The Commission has issued the enclosed Amendments Nos. 34, 34 and 31 for Licenses Nos. DPR-38, DPR-47 DPR-55 for the Oconee Nuclear Station, Units Nos. 1, 2 and 3. These amendments consist of changes to the station Technical Speicifications and are in response to your request dated July 21, 1976, as supplemented August 28, October 7, October 19, October 20, and October 20, 1976.

DUKE POWER COMPANY

OCONEE NUCLEAR STATION, UNIT 1

Amendment No. 34
License No. DPR-38

Figure 2.1-1C

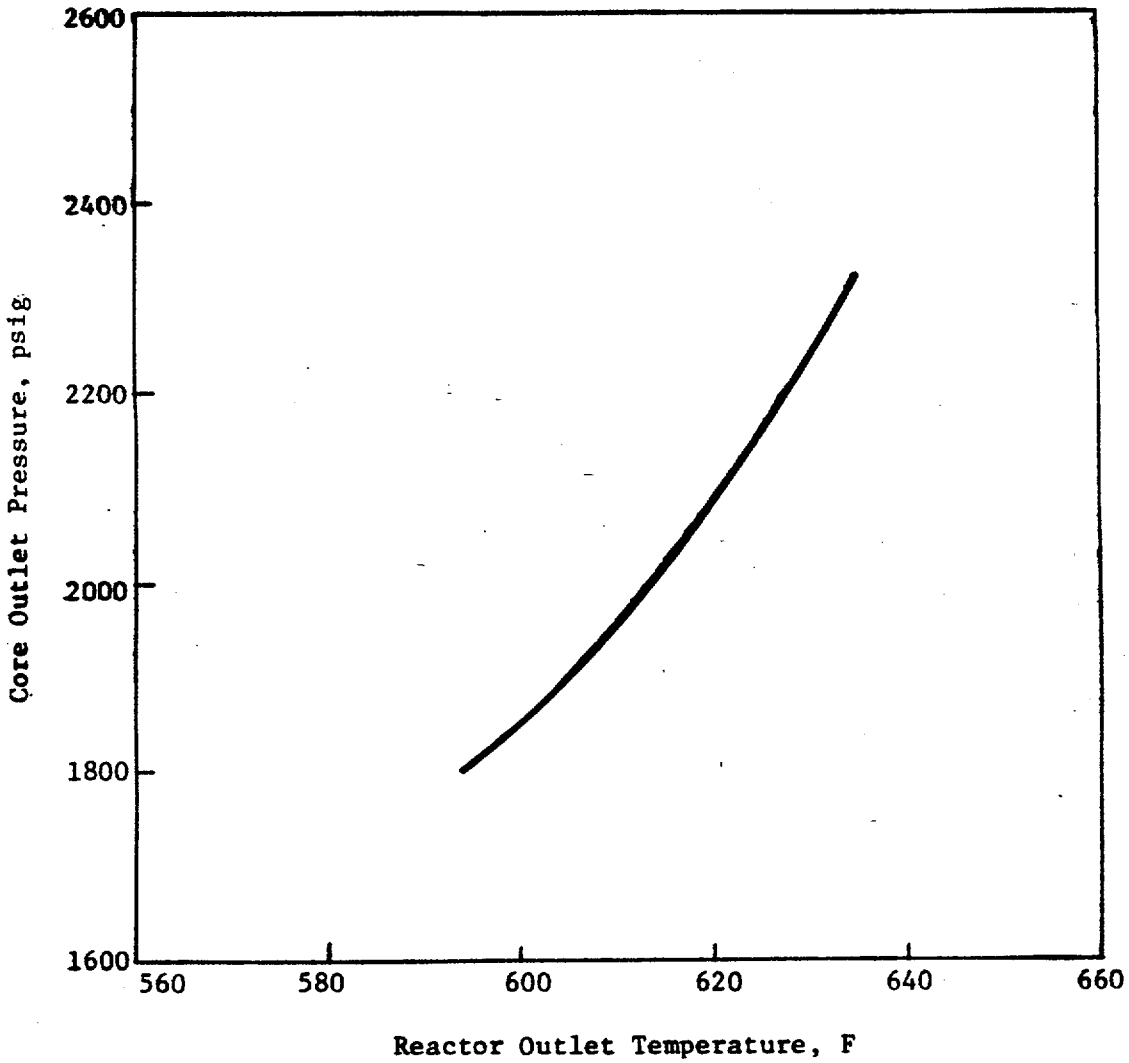
The curve presented in Figure 2.1-1C represents the conditions at which a minimum DNBR of 1.30 is predicted for the maximum possible thermal power (112 percent) when four reactor coolant pumps are operating (minimum reactor coolant flow is 141.3 x 10^6 lbs/hr.). This curve is based on the following nuclear power peaking factors with potential fuel densification and fuel rod bowing effects: $F_q^N = 2.67$; $F_{\Delta H}^N = 1.78$; $F_z^N = 1.50$. The design peaking combination results in a more conservative DNBR than any other power shape that exists during normal operation.

The curve of Figure 2.1-1C is the most restrictive of all possible reactor coolant pump-maximum thermal power combinations shown in Figure 2.1-3C.

Figure 2.1-2C

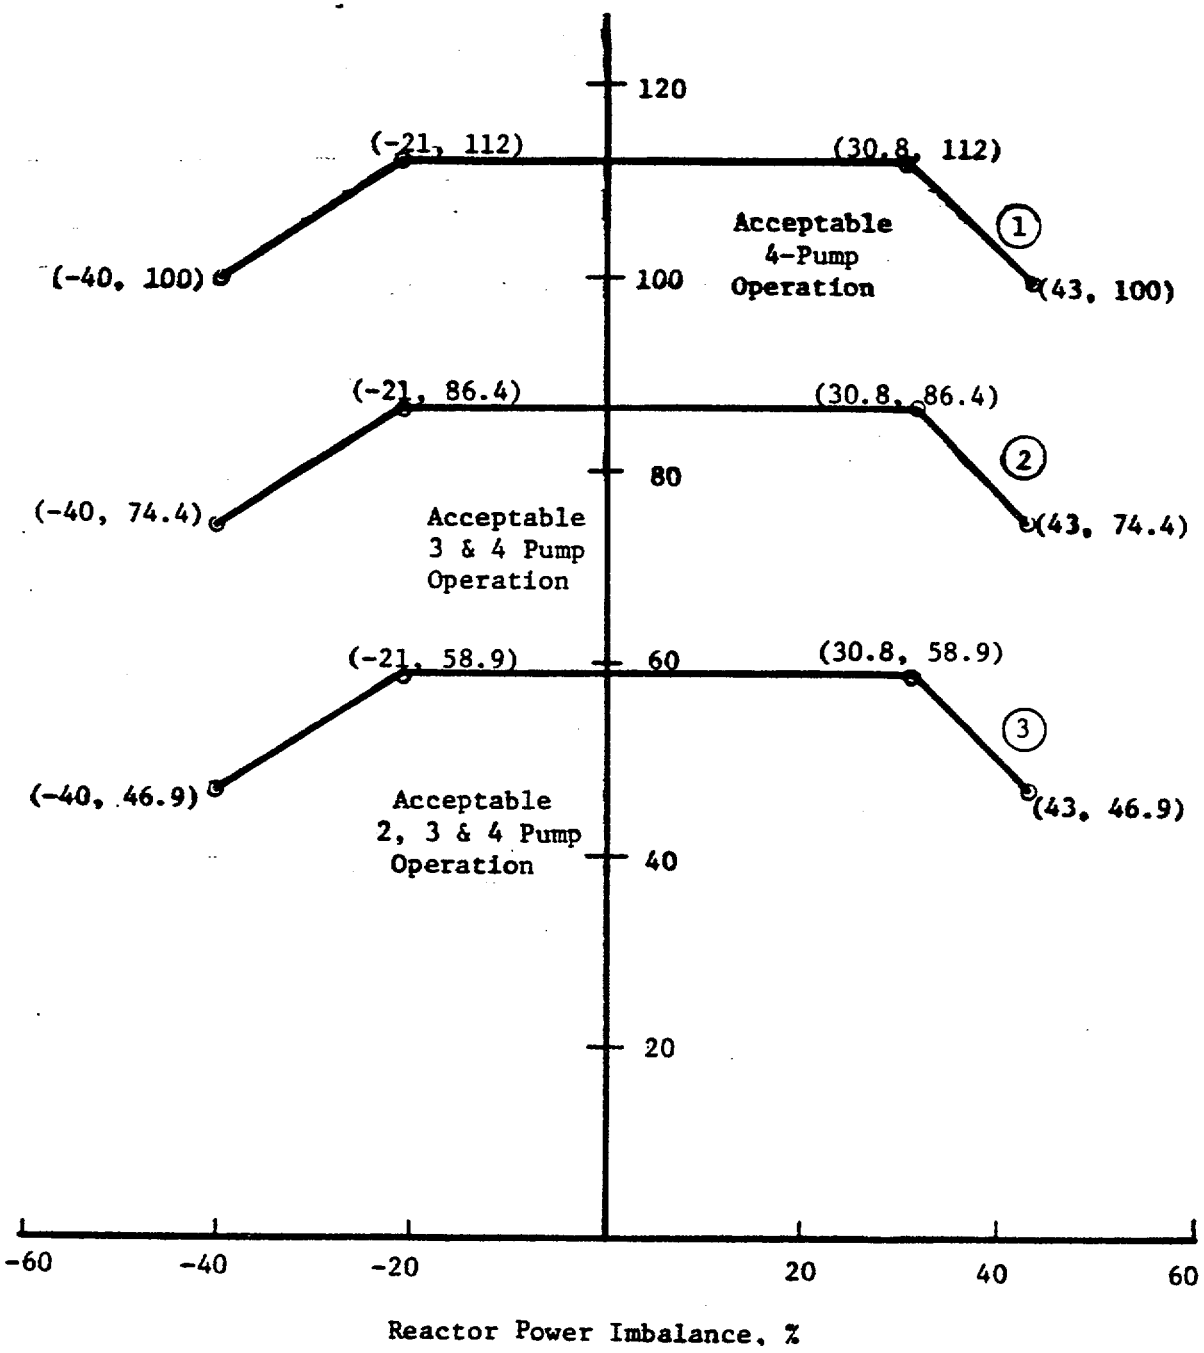
The curves of Figure 2.1-2C are based on the more restrictive of two thermal limits and include the effects of potential fuel densification and fuel rod bowing.

The specified flow rates for Curves 1, 2 and 3 of Figure 2.1-2C correspond to the expected minimum flow rates with four pumps, three pumps and one pump in each loop, respectively.

Figure 2.1-3C

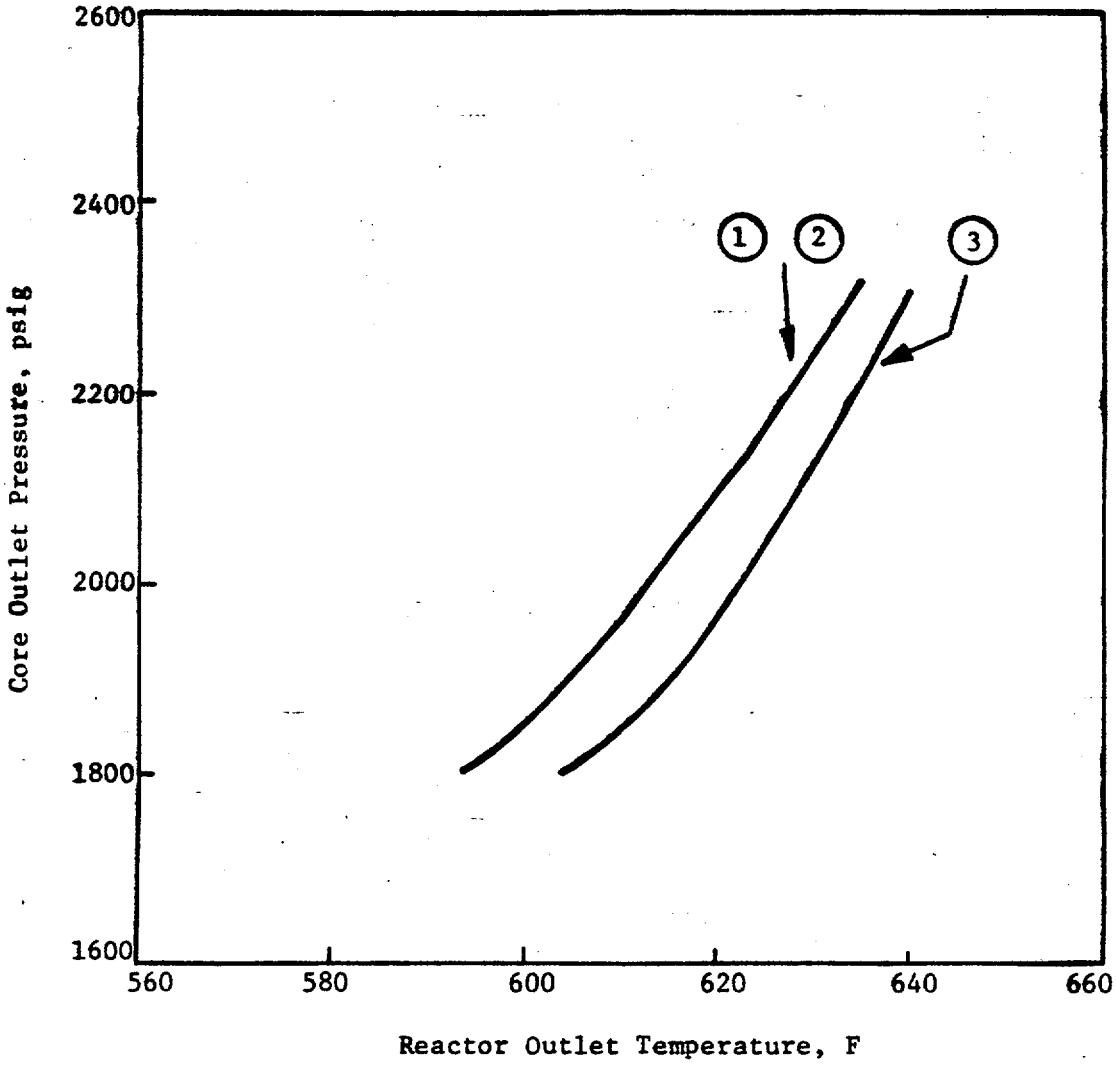
For each curve of Figure 2.1-3C a pressure-temperature point above and to the left of the curve would result in a DNBR greater than 1.30 or a local quality at the point of minimum DNBR less than 22 percent for that particular reactor coolant pump situation. The 1.30 DNBR curve for four-pump operation is more restrictive than any other reactor coolant pump situation because any pressure/temperature point above and to the left of the four-pump curve will be above and to the left of the other curves.

Figure 2.3-1C

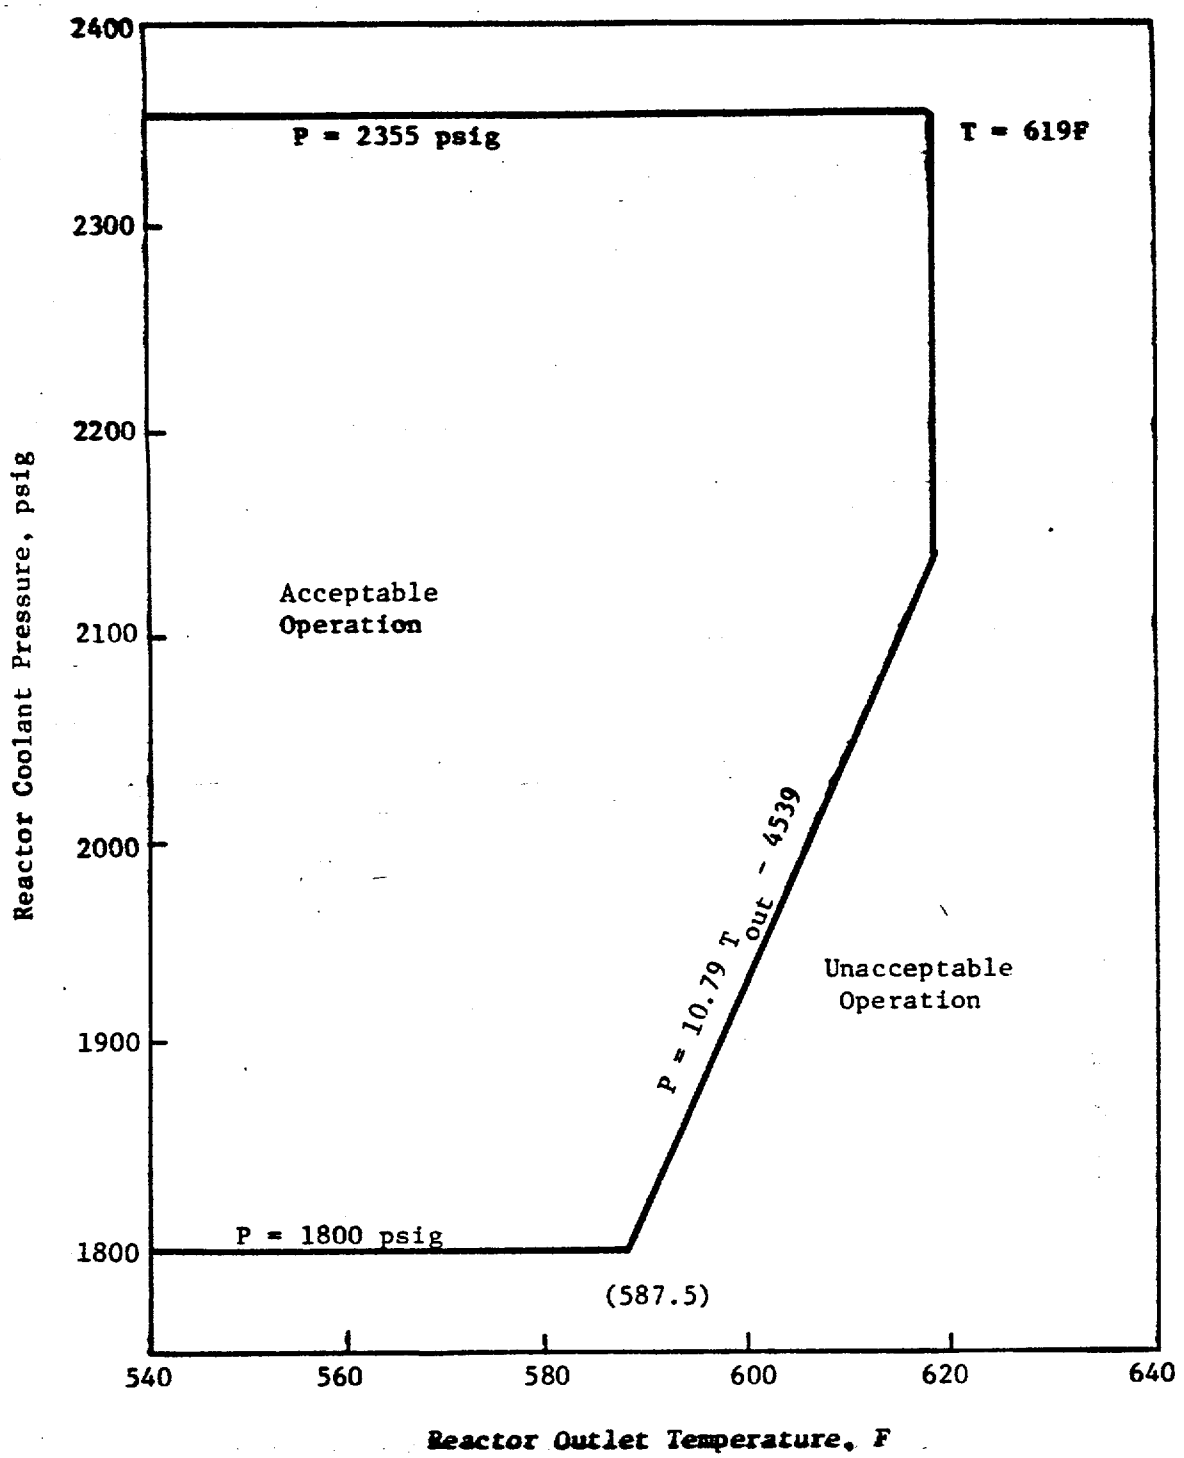
The low pressure (1800) psig and variable low pressure (11.14 T_{out}-4706) trip
(1800) psig (10.79 T_{out}-4539)
(1800) psig (10.79 T_{out}-4539)
setpoints shown in Figure 2.3-1A have been established to maintain the DNB
2.3-1B
2.3-1C
ratio greater than or equal to 1.3 for those design accidents that result in a pressure reduction. (2,3)

The high reactor coolant outlet temperature trip setting limit (619 F) shown in Figure 2.3-1A has been established to prevent excessive core coolant
2.3-1B
2.3-1C
temperatures in the operating range. Due to calibration and instrumentation errors, the safety analysis used a trip set point of 620°F.

Figure 2.3-2C

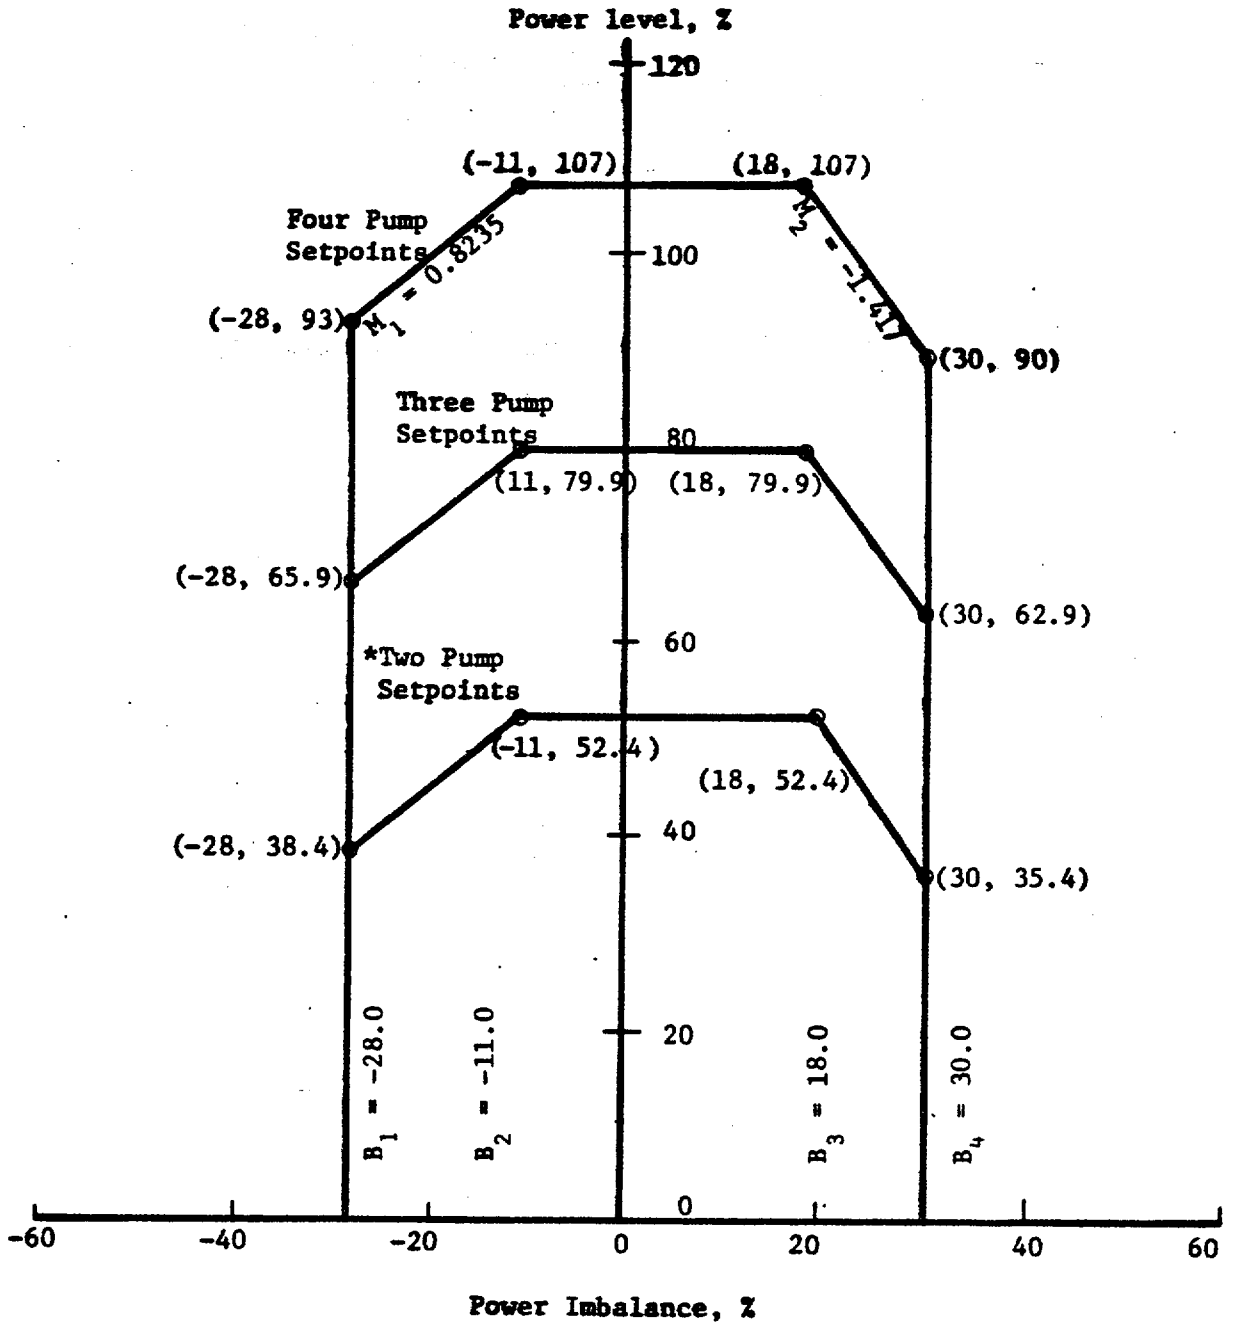
The power-imbalance boundaries are established in order to prevent reactor thermal limits from being exceeded. These thermal limits are either power peaking kw/ft limits or DNBR limits. The reactor power imbalance (power in the top half of core minus power in the bottom half of core) reduces the power level trip produced by the power-to-flow ratio such that the boundaries of Figure 2.3-2A - Unit 1 are produced. The power-to-flow ratio reduces the power

level trip and associated reactor power/reactor power-imbalance boundaries by 1.055%-Unit 1 for a 1% flow reduction.
1.07% - Unit 2
1.07% - Unit 3
For Unit 1, the power-to-flow reduction ratio is 0.949, and for Units 2 and 3, the power-to-flow reduction factor is 0.961 during single loop operation.
